# City of San Antonio

Re: **Potranco Market**

**MDP # 022-07**

The City Staff Development Review Committee has reviewed Marbach Village Subdivision Master Development Plan **MDP # 022-07**. Please find enclosed a signed copy for your files. Your plan was approved for acceptance, however please note the following:

# POTRANCO MARKET MASTER DEVELOPMENT PLAN

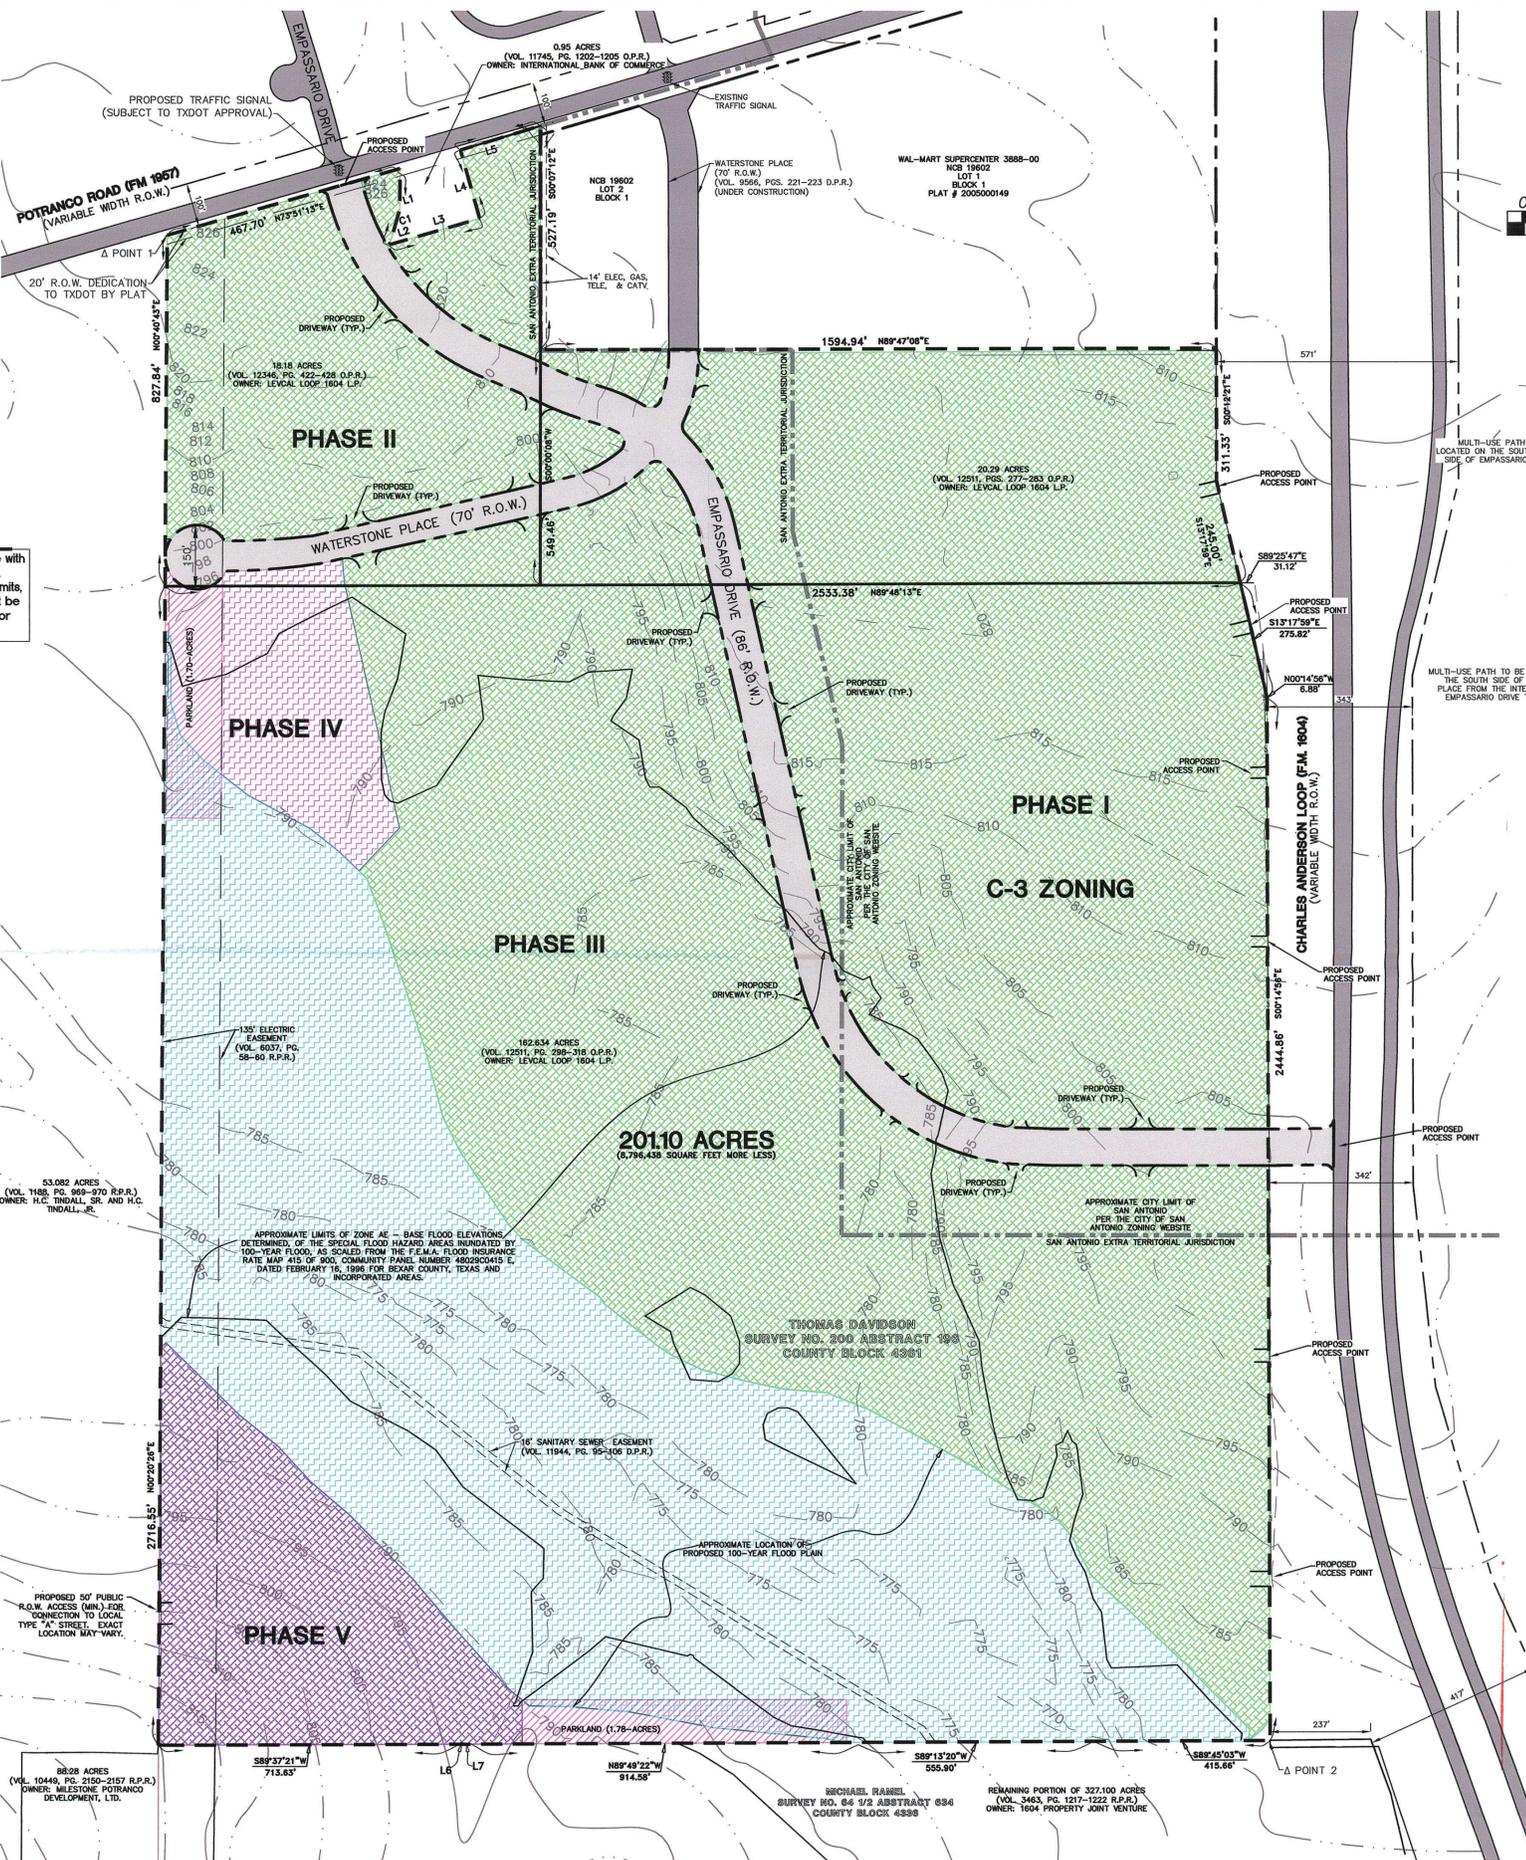
- All commercial driveways for this project shall comply with UDC 35-506, (r) Access and Driveways.
- All access driveways shall provide clear sight distance along Empresario Drive and along Loop 1604 to provide adequate obstruction-free viewing distances for approaching traffic. All signage, landscaping, and improvements shall be selected and located so as to not block these clear sight distance areas.

- All roadways shall follow UDC 35-506 Transportation and Street Design and shall comply with UDC 35-502.
- Coordinate with TXDOT on installation of proposed traffic signal system at the intersection of Potranco Road and Waterstone Place.

- Coordinate with TXDOT on installation of recommended traffic signal system at the intersection of Potranco Road and Empresario Drive.
- Coordinate with TXDOT on the need for extending the left-turn lanes on Potranco Road through the intersection with Loop 1604 to provide additional capacity on the east-west approaches.

- Coordinate with TXDOT on the need for required roadway markings for turn lanes.
- Coordinate with TXDOT on access points along Loop 1604 (Driveways A to E).

- Provide right-turn deceleration lane for the following:
  1. Southbound approach to Driveway A, B, C and D on Loop 1604 Southbound Frontage Road.
  2. Southbound approach to Empresario Drive on Loop 1604 Southbound Frontage Road.

3. Eastbound approach to Empresario Drive on Potranco Road.
- Design all driveways along the Loop 1604 Southbound Frontage Road as right-in/right-out only driveways with appropriate signage to reduce the potential for wrong-way movements.

- Extend Empresario Drive south to Loop 1604 to provide direct access to the site.
- Extend Waterstone Place as a collector roadway between Potranco Road and Empresario drive to accommodate traffic from the retail development.

**Tree Preservation:** This Master Development Plan meets the criteria of the 2003 Tree Preservation ordinance (Section 35-B125 and Table 35-B101).

- 1997/2006 Tree Preservation ordinance standards per UDC Section 35-523 – a Tree Preservation Plan is required prior to any work on site. This can be submitted either as a clearing permit or at the platting stage. This project appears to be suited to a Tree Stand Delineation (30% preservation of tree canopy at MDP or 35% preservation at platting) based on the large lot sizes and tree canopy area. Note that flood plain area must be delineated separately (preserved at 80% for significant trees and 100% for heritage trees).

- Landscape ordinance per UDC Section 35-511 for area inside City of San Antonio limits. It appears some landscape points can be met by preserving existing vegetation as well as meeting any mitigation requirements (either through preservation of smaller material or transplanting). Recommend securing knowledgeable Landscape Architect at planning and design phase to better utilize existing trees and vegetation. Preservation will eliminate the need for irrigation. Staff would be willing to meet with developer at design stage to assist with tree preservation and landscape plan.

- Streetscape standards per UDC Section 35-512 – Embassario Drive and Waterstone Place required streetscape on the new ROW (recommend preservation of existing trees where available and possible).

**Parks and Recreation Department:** recommend approval of Potranco Market Master Development Plan with the following conditions:

- The parkland provided shall be shown as "Park" or "Open Space" on a plat; UDC section 35-503(e) *Designation of Parkland*.
- The parkland provided is dedicated to the Home Owners Association.
- The instruments creating the Home Owners Association are provided by the second application for plat approval; UDC section 35-503(e) *Designation of Parkland*.
- Parkland dedication must be platted by the second phase of residential development; UDC section 35-503(f) *Development Phasing*.
